# **Town of Hilton Head Island Regular Design Review Board Meeting**

**Tuesday, March 27, 2012**

**Town of Hilton Head Island**  
**Design Review Board**  
**Minutes of the Tuesday, March 13, 2012 Meeting**      **DRAFT**  
**1:15p.m – Benjamin M. Racusin Council Chambers**

**Hilton Head Christian Academy** – Practice Gym - DR120004

A Landscape Plan for:  
**Hilton Head Christian Academy  
New Gymnasium and Classroom Building**  
Gardner Drive Hilton Head Island, SC

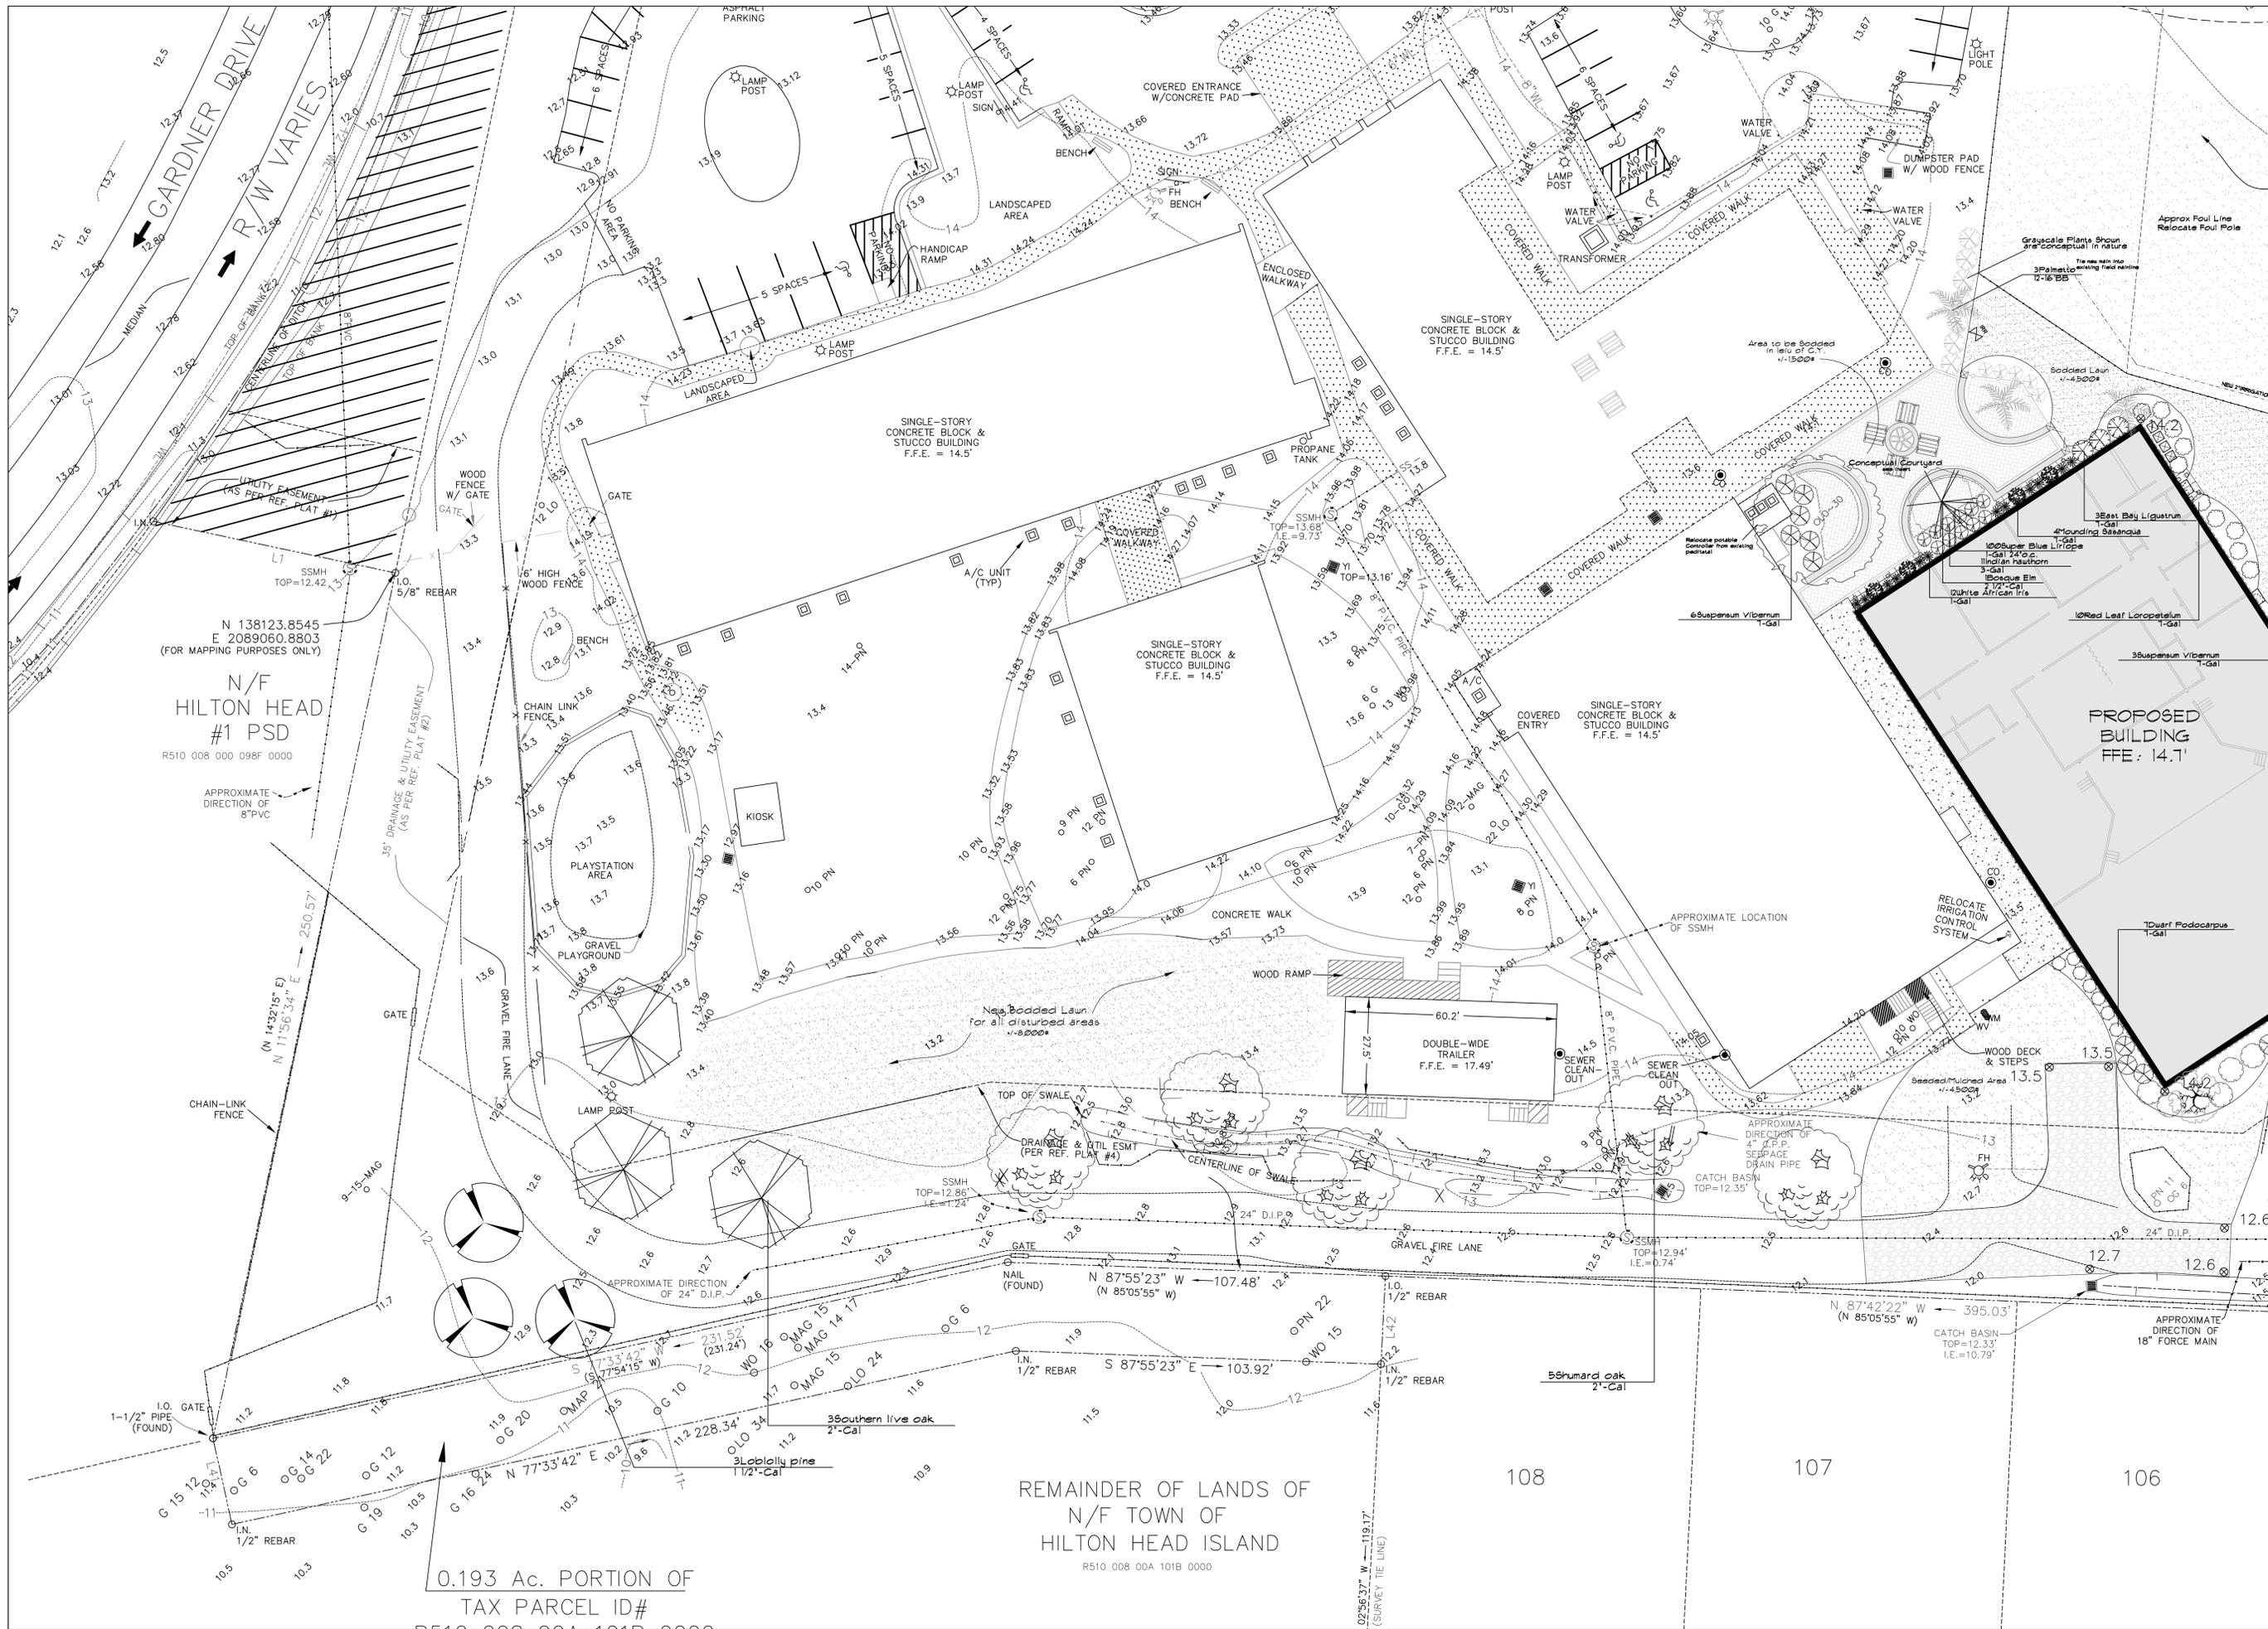
The Natural Resources has reviewed and approved the proposed tree removal and mitigation plan. All replacement trees will be field located and approved by Town staff. Staff recommended that the application be approved with conditions. At completion of the staff's presentation, Chairman Theodore requested that the applicant make his presentation.

Mr. Greg Beste, Architect, presented statements in support of the application. The applicant discussed the building, the trellis, the courtyard, and the landscaping plan. The Board stated the need for additional architectural detail on the gable end of the building. The Board also discussed the landscape plan particularly regarding the south elevation. The Board and applicant discussed the size and the species of plant material.

***Natural Resources has reviewed and approved the proposed tree removal and mitigation plan. All replacement trees will be field located and approved by Town Staff***

NORTH ELEVATION

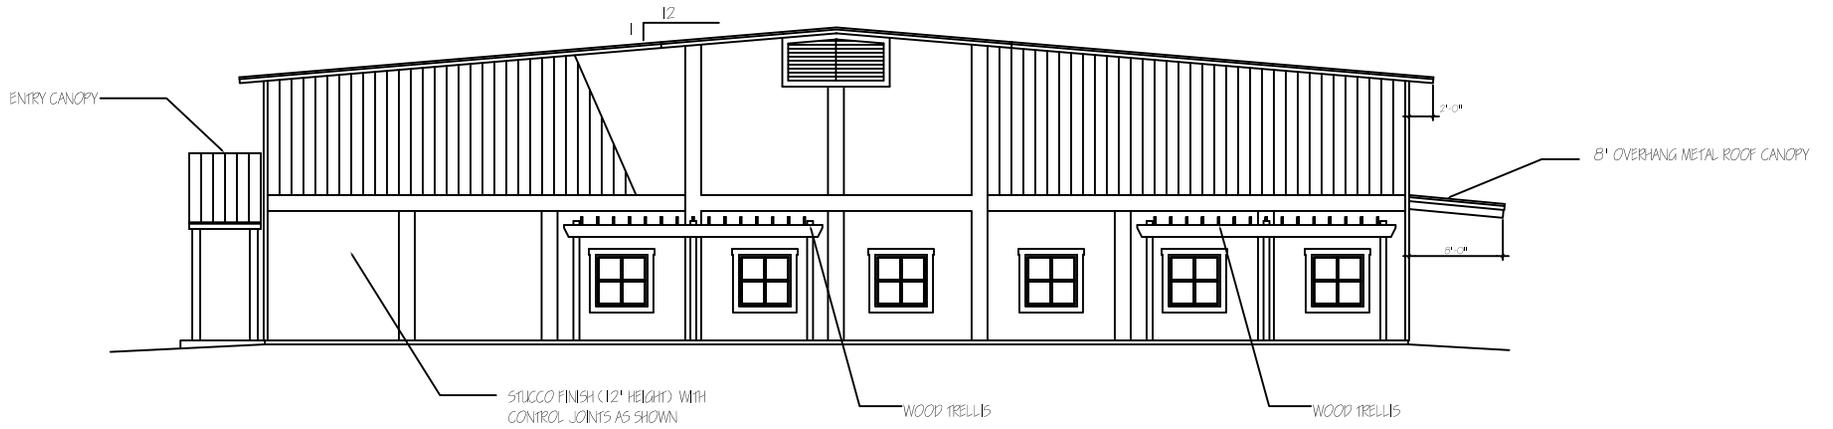
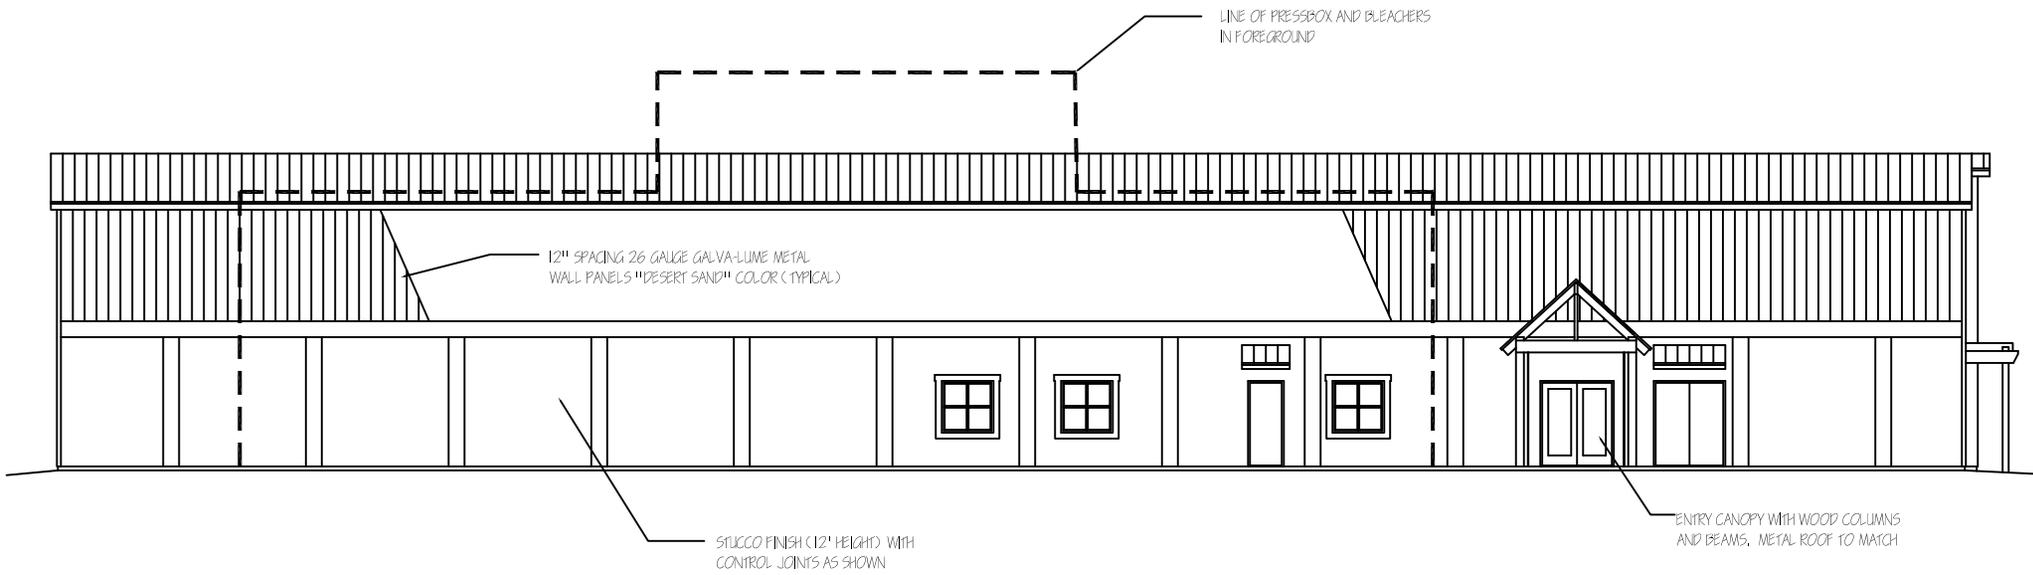
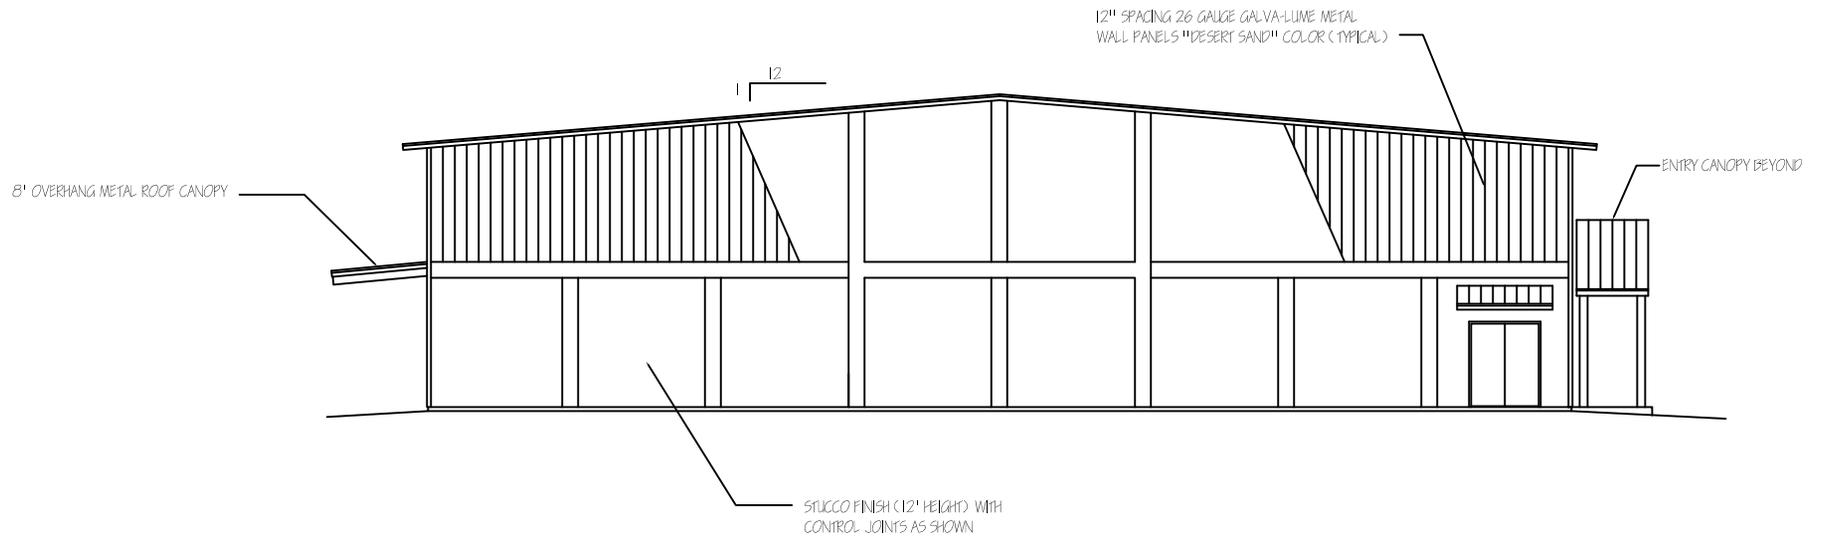
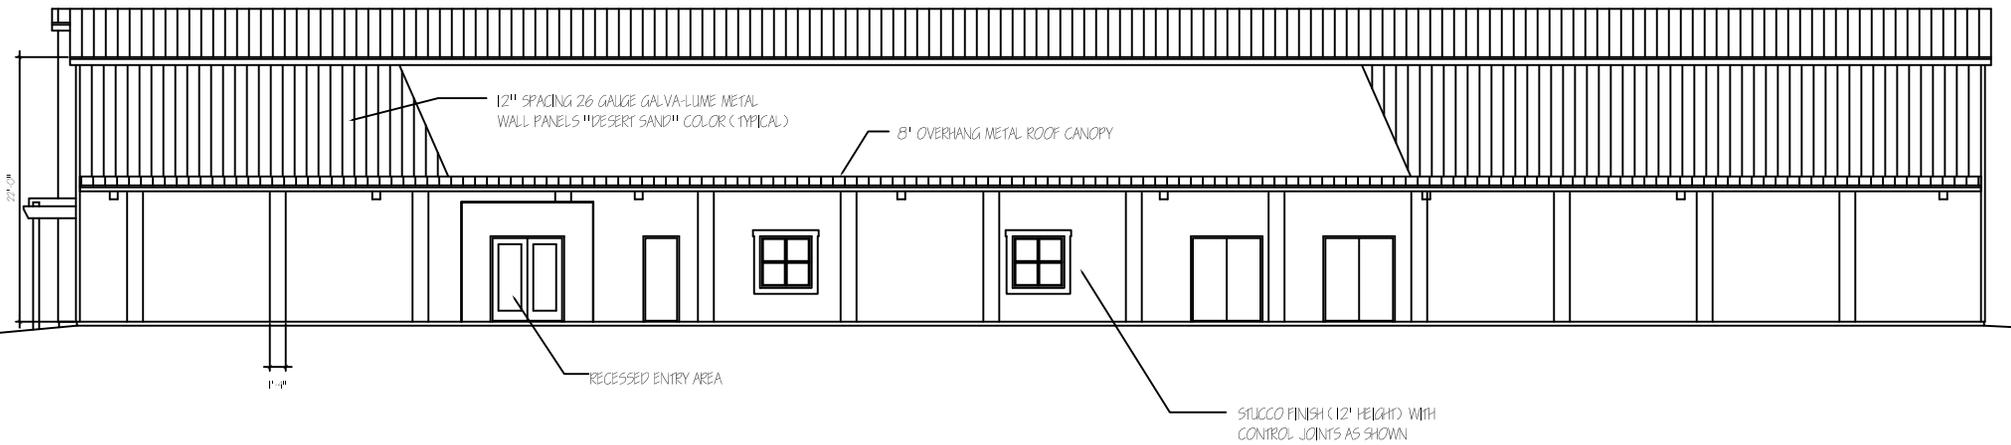
Mr. Roan presented a brief history of the application. The Board is reviewing this application for the third time. The conceptual application for this project was approved on February 14<sup>th</sup> with conditions. Since the project's last review on February 28<sup>th</sup>, the applicant has introduced stucco on all four sides of the building bringing it closer to Design Guide criteria. The trellis and entry features also add some wood elements to the structure. Mr. Roan presented a visual review of the elevations. Staff feels that the south elevation is still sparsely composed, but fits the program of interior. At the previous submission implied pilaster utilized in the stucco elements, where they are now labeled as control joints. Pilasters might add some shadow to the facades. Overhang is now introduced on the

1/12 roof. The allowance of the metal building set the precedent for a project that was driven by cost over the quality of the detailing, so in that light the project has moved significantly closer to what the Board was recommending for approval. The trellises seem to exist for their own sake, and are under-proportioned, relative to depth and material dimensions.

Avoids monotonous planes or unrelieved repetition	<input checked="" type="checkbox"/>	<input type="checkbox"/>	<input type="checkbox"/>	Altering the stucco finishes on the gable ends and extending the rake addresses Board comments
Has a strong roof form with enough variety to provide visual interest	<input checked="" type="checkbox"/>	<input type="checkbox"/>	<input type="checkbox"/>	To the extent requested by the Board
Minimum roof pitch of 6/12	<input type="checkbox"/>	<input checked="" type="checkbox"/>	<input type="checkbox"/>	
Overhangs are sufficient for the façade height.	<input checked="" type="checkbox"/>	<input type="checkbox"/>	<input type="checkbox"/>	
Forms an details are sufficient to reduce the mass of the structure	<input checked="" type="checkbox"/>	<input type="checkbox"/>	<input type="checkbox"/>
